# Some Comments about Absorber Integration

**Michael A. Green**  
**Lawrence Berkeley National Laboratory**

This short document is a guide to Ed Black and others as to how I think the focusing magnet should be integrated with the absorber for the MICE proposal. I have assumed that Ed Black's drawing will be the central drawing describing the experiment. That drawing must present a credible scenario for integrating the absorber with the focusing coil pair. The focusing coils used for this study are the latest used in Bob Palmer's ICOOL simulations. These coils are shorter with a smaller space between them. As a result, they fit into the focusing magnet cryostat better. Figures 1 through 4 at the end of this document illustrate my thoughts on the subject of integration. In order to create the drawings in Figures 1 through 4, I made a number of assumptions that may require collaboration approval.

Figure 1

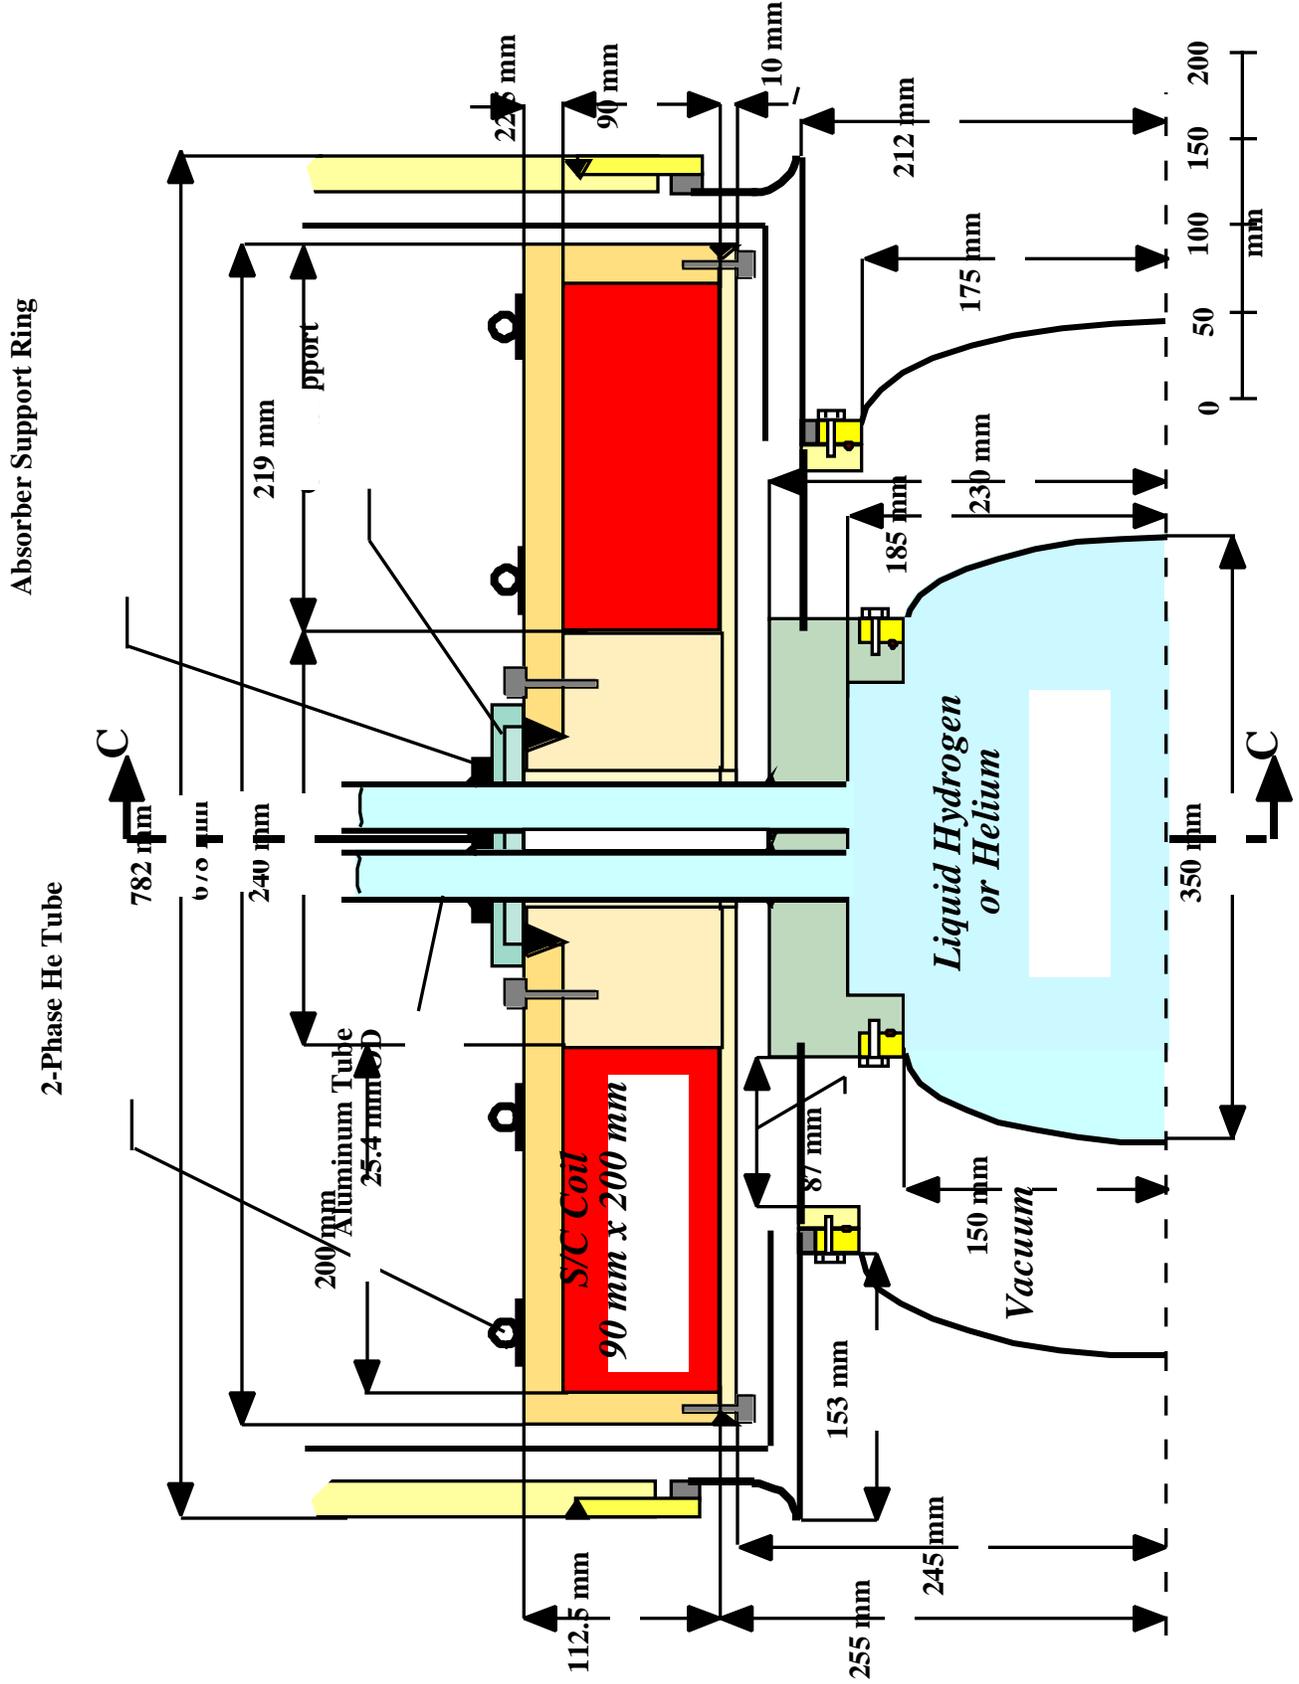
The assumptions are as follows: 1) The inner window diameter was set at 300 mm with a 20 to 25 mm wide rim around that window (see Fig. 1). 2) The outer window (safety window) was set at 350 mm with a 20 to 25 mm-wide rim around the window (see Fig. 1). For both windows the rim thickness was set at about 12 mm, but the rim could be as thin as 6.4 mm. 3) The inner window temperature is set to be the temperature of the fluid in the absorber. (The fluid temperature is 18 to 20 K at 1 bar when the absorber contains hydrogen. When the absorber contains helium the temperature is set at 4.8 to 5.0 K at 2 bar (30 psia).) 4) The outer window temperature must be greater than 50 K. Having the outer window at a temperature above 50 K means that oxygen in the RF cavity vacuum space will not freeze out on the outer window surface. Because the outer window temperature is higher than the inner window temperature, the space between the windows must be evacuated. A cylinder of 5456 aluminum is between the inner and outer window. The heat used to keep the outer window temperature above 50 K is carried to the window by radiation and by conduction along a thin wall 304 stainless tube that forms the inner cryostat for the magnet. 5) At least one set of absorber windows is removable for the proposal. There are several candidates for the window seal material. Because the space between the windows and outside is pumped and kept under vacuum, the leak rate for the window seals can be as high as  $10^{-7}$  atm cc per second. 6) The vacuum spaces between the pair of inner and outer windows are connected to each other through a 12 by 30-mm slot in the absorber body that connects the two vacuum volumes. The vacuum volume between the windows is connected to the outside world through a pair of 25 mm OD tubes that connect the absorber body to a vacuum tank that is outside of the cryostat (See Fig 2). The tubes leaving the absorber are made from aluminum. A transition from aluminum to stainless steel tube would occur out side of the magnet support structure. Once the transition from aluminum tube to stainless steel tube has been made, the tube can become flexible stainless steel hose. 7) The liquid filled portion of the absorber is connected to the outside through a pair of vertical 25-mm OD tubes that form the neck of the liquid cryogen vessel. These tubes are also made from aluminum. 8) The absorber body is assumed to be supported from the aluminum tubes that come out of the cryogen tank of the absorber. It is assumed that these tubes are in turn supported from magnet coil support structure through a low heat leak NEMA G-10 spider. Other approaches for supporting the absorber are possible. 9) The heat exchanger between the liquid in the absorber body and the helium flowing through the case is an extended surface heat exchanger that goes up each side of the absorber case from a point at an angle of  $-75$  degrees to  $+75$  degrees. (The extended heat transfer surface is shown in Figure 3.) 10) The absorber body diameter is shown as 460 mm. The inner diameter of the inner magnet support structure is shown at 490 mm. Thus the clearance between the absorber body and the inner cold surface of the magnet is 15 mm. 11) The cooling for the superconducting coil is from tubes attached to the outer support shell around the superconducting coils. This support shell is assumed to be made from forged 6061-T6 aluminum. The potted coils are machined and shrunk fit into the two halves of the support structure. The two halves of the support structure are welded together when the magnet is assembled around the absorber body with it pipes coming out of it top and bottom. 12) The pipes that come out of the absorber body run vertical rather than in the radial direction. See the pipes in Figure 4.

Figure 2

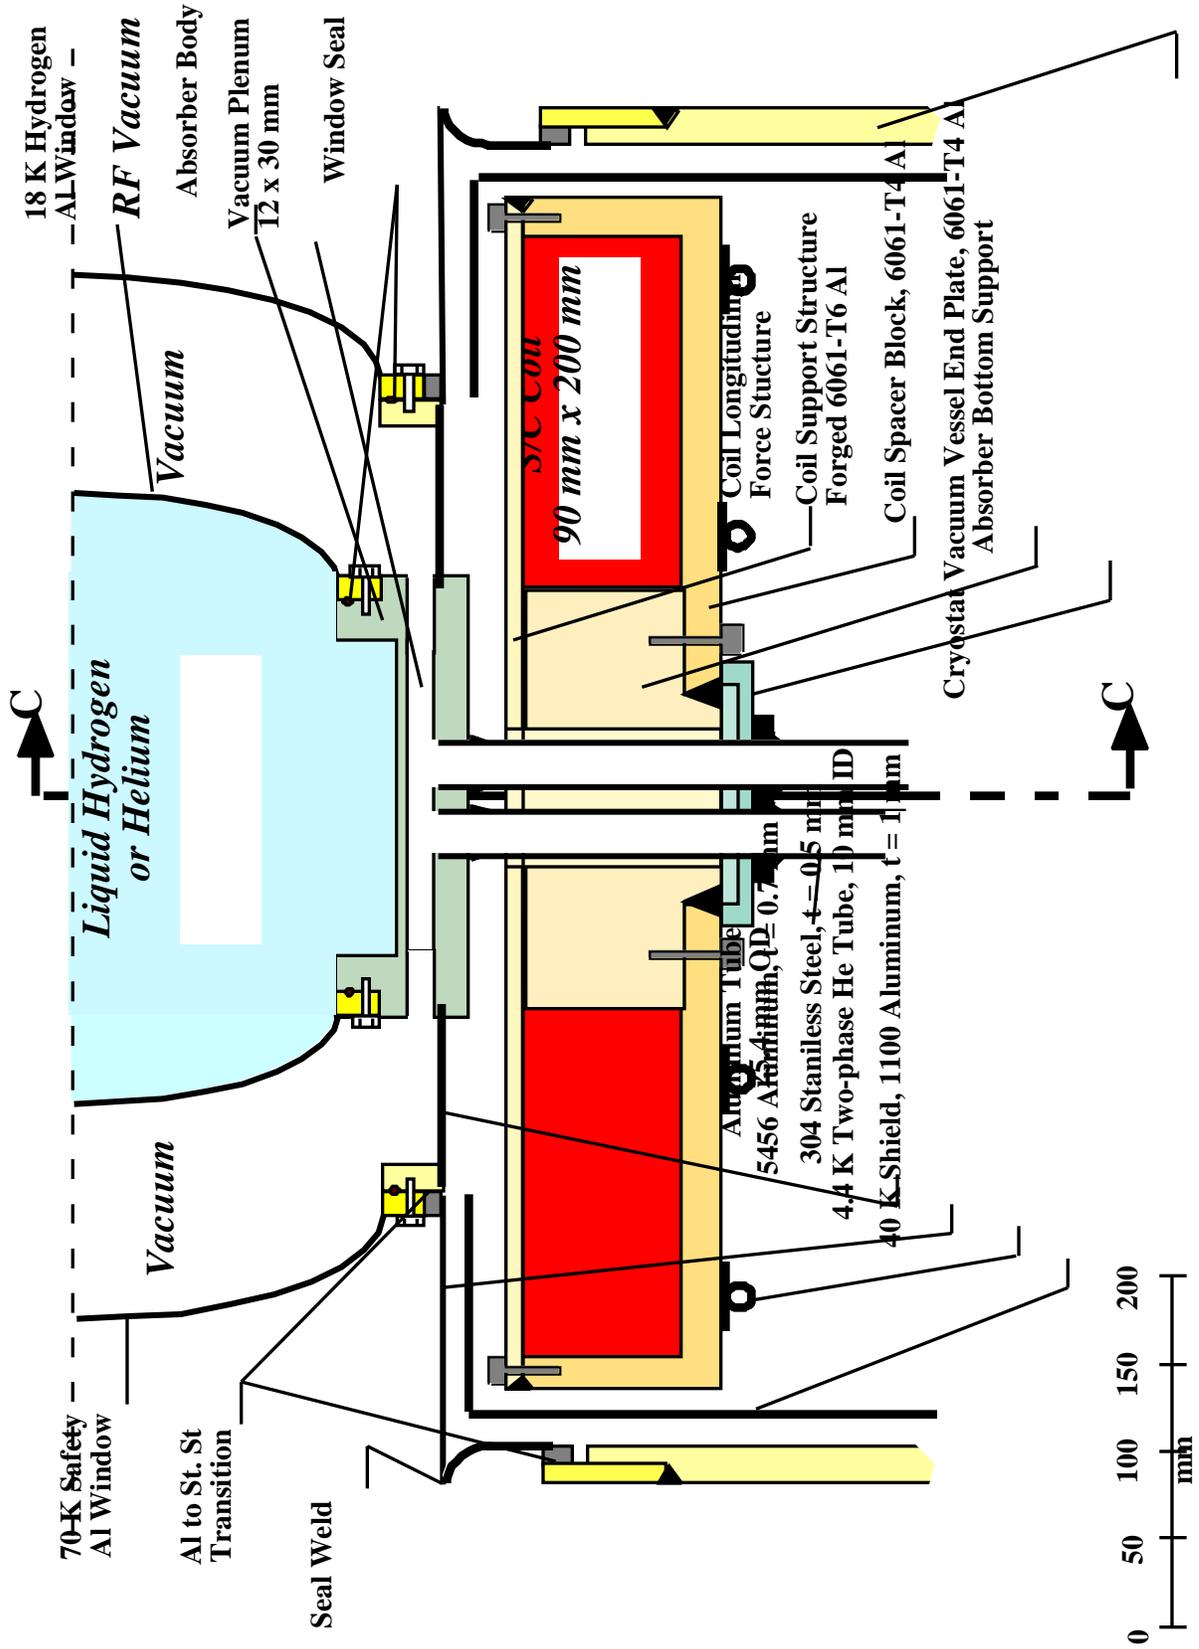
The bladder is not shown in Figures 1 through 3. It is not clear that a bladder to shorten the cryogen path will be included in the proposal. Two different types of bladders have been proposed. They are the double bladder (a single shaped Mylar or kapton sheet next to each window) or a single bladder that is in the center of the absorber (a ring with two shaped Mylar or kapton sheets). The double bladder has the stated advantage of moving the liquid to the low beta center section of the absorber. The double bladder is more complicated in that helium must be fed to the space between the window and the bladder sheet. The single bladder with two sheets is simpler to build and it can be supported from a couple of points on the absorber inner wall. The single bladder can have a single capillary tube that carries helium to the bladder. This tube can up one of the two necks that go vertically out of the absorber. The stated disadvantage of the single bladder is the fact that all of the liquid cryogen is in the higher beta portion of the absorber.
